Studebaker

# SERVICE BULLETIN

NO. 278

1953

FIG. 1 • 1. 5-OHM RESISTOR (PART NO. 533130)  
2. BLACK WIRE TO CYLINDER HEAD UNIT

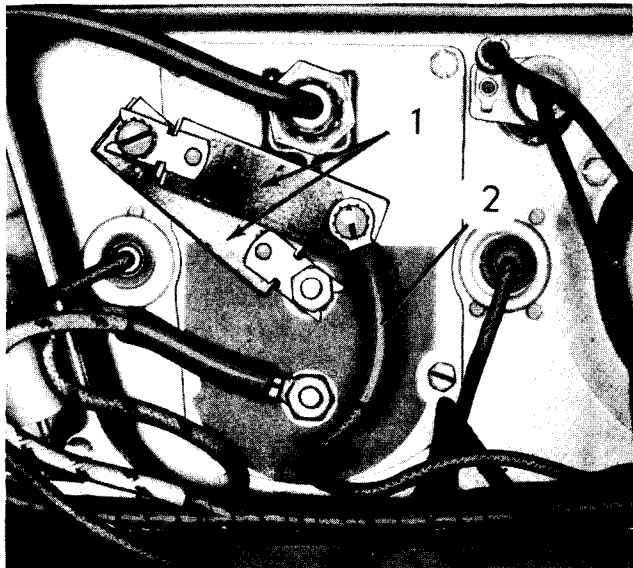
To correct, install two 5-ohm resistors (Part No. 533130) in series on the receiving terminal of the heat indicator gage. See Fig. 1.

THE BLACK WIRE (2) IS REMOVED FROM ITS TERMINAL ON THE BACK OF THE HEAT INDICATOR GAGE. THE SPADE TERMINAL OF A 5-OHM RESISTOR (1) IS SECURED ON THIS TERMINAL. A SECOND 5-OHM RESISTOR (1) IS CONNECTED TO THE FIRST AS SHOWN AND THE BLACK WIRE (2) IS THEN ATTACHED TO THE SCREW TERMINAL OF THE SECOND RESISTOR. (PICTURE SHOWS INSTALLATION ON A CHAMPION MODEL: IT IS DONE IN THE SAME WAY ON COMMANDER MODELS.)

FIG. 2 • 1. RUBBER GASKET 2. BRASS SPRING SEAT

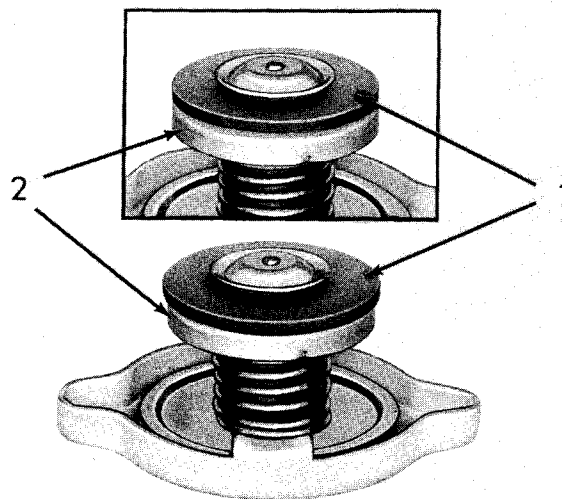
THE RUBBER GASKET (1) OF THE PRESSURE CAP AT THE TOP OF THIS PICTURE IS THE RIGHT SIZE. IT DOES NOT PROTRUDE OVER THE EDGE OF THE BRASS SPRING SEAT (2). IN THE PRESSURE CAP AT THE BOTTOM OF THE PICTURE, THE GASKET (1) IS OVER-SIZE AND EXTENDS BEYOND THE EDGE OF THE SPRING SEAT (2). THIS PRESSURE CAP SHOULD BE DISCARDED.

essary. Examine the new radiator cap to be sure that the rubber gasket does not extend beyond the edge of the brass spring seat (see Fig. 2). Use only caps in which the rubber gasket is
